DART AEROSPACE LTD		Work Order:	89194
Description: Bracket		Part Number:	D3183-3
Inspection Dwg: D3183	Rev: C1	Page 1 of 1

DESIGN #		DRAWN BY CP		<b>DART AEROSPACE LTD</b> HAWKESBURY, ONTARIO, CANADA	
CHECKED #		APPROVED #		DRAWING NO. <b>D3183</b>	
DATE <b>04.02.17</b>		TITLE <b>BRACKET ASSEMBLY</b>		REV. C SHEET 1 OF 4 SCALE 1:1	
A	03.01.24	NEW ISSUE			
B	03.06.17	REMOVE BEARING; 1.012 WS 0.882			
C	04.02.17	ADD -045/-9; 0.182 WAS 0.431			
C1	# 04.11.09	0.830 WAS 0.850

DRAWING NO. D3183	TITLE BRACKET ASSEMBLY	REV.C1	DART AEROSPACE LTD ENGINEERING ORDER		D.E.O. NO. D3183-C1-1	SHEET NO. SHEET 1 OF 1	SCALE NTS
DRAWN qp	CHECKED [Signature]	MFG. APPR. [Signature]	APPROVED [Signature]		DE APPR. [Signature]		
DATE 10.05.14	DATE 10.06.30	DATE 10.06.30	DATE 10/06/30		DATE 10/06/30

D3183-5 BEARING

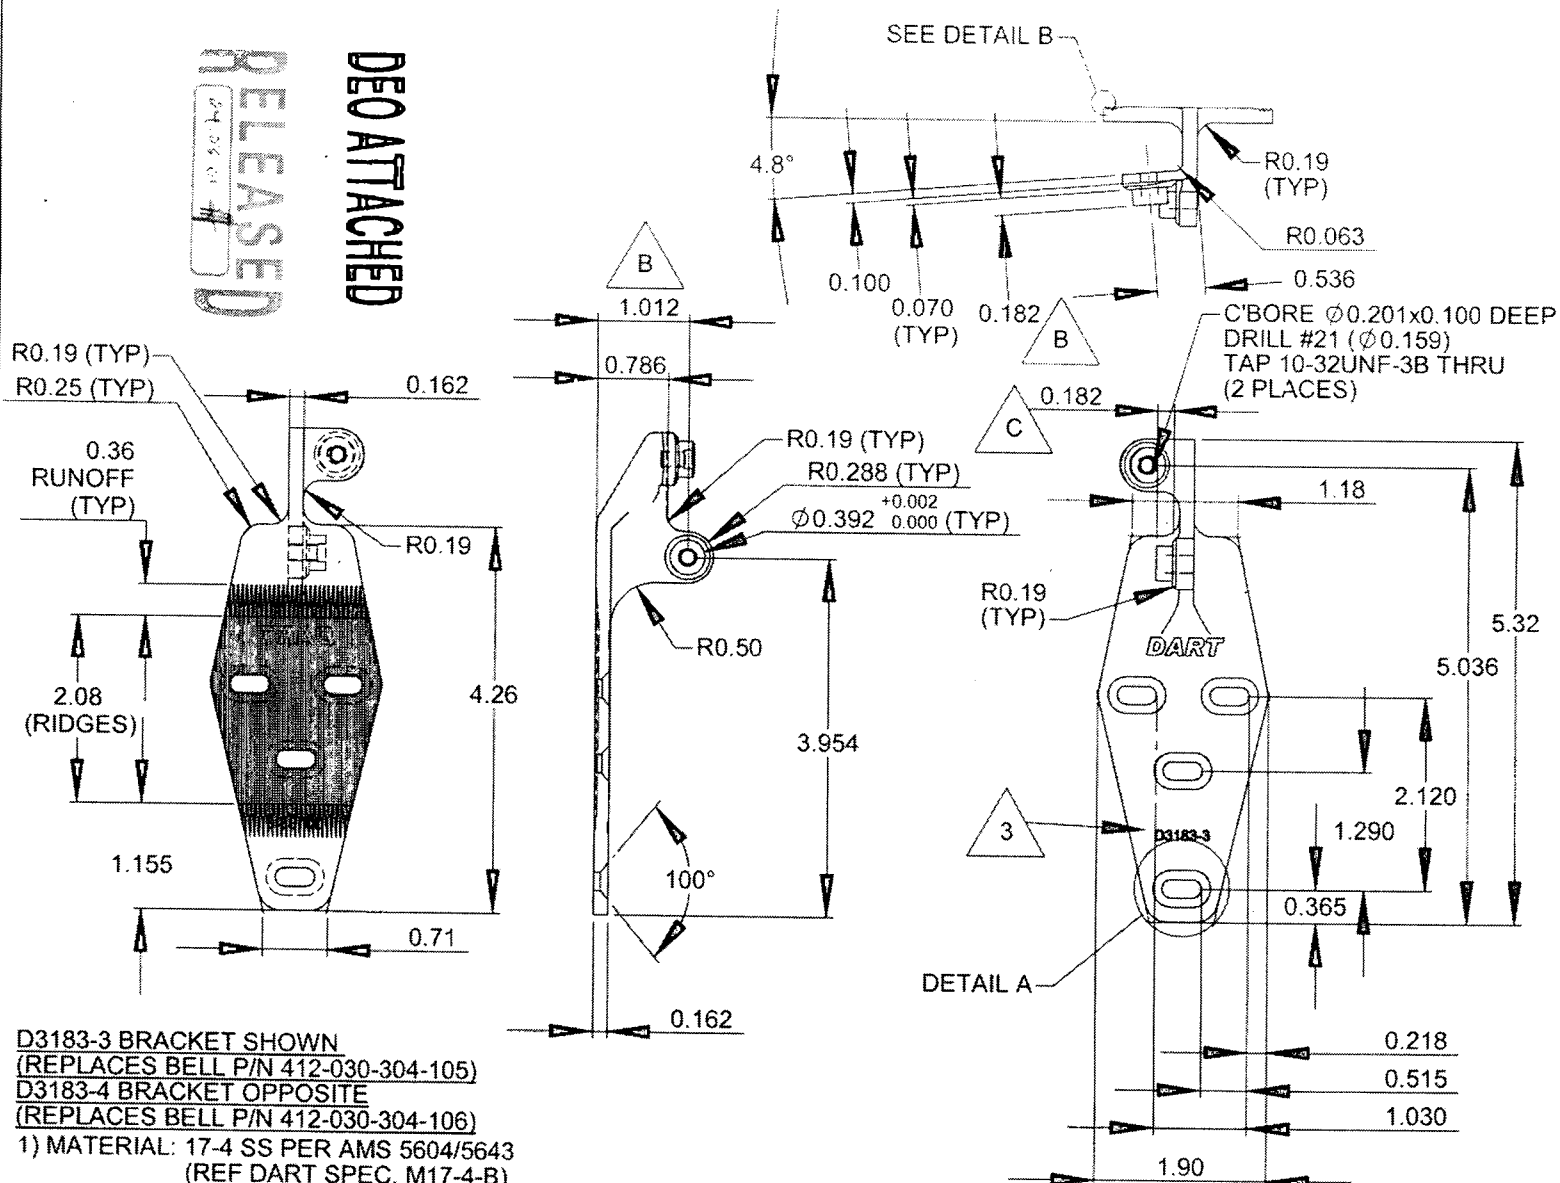
ADD POSSIBLE SUPPLIER: KML P/N 6800-ZZ

BASIC LOAD RATING REQUIREMENT: Cr = 1720 N (386 lb) MIN [DYNAMIC]  
Cor = 840 N (188 lb) MIN [STATIC]
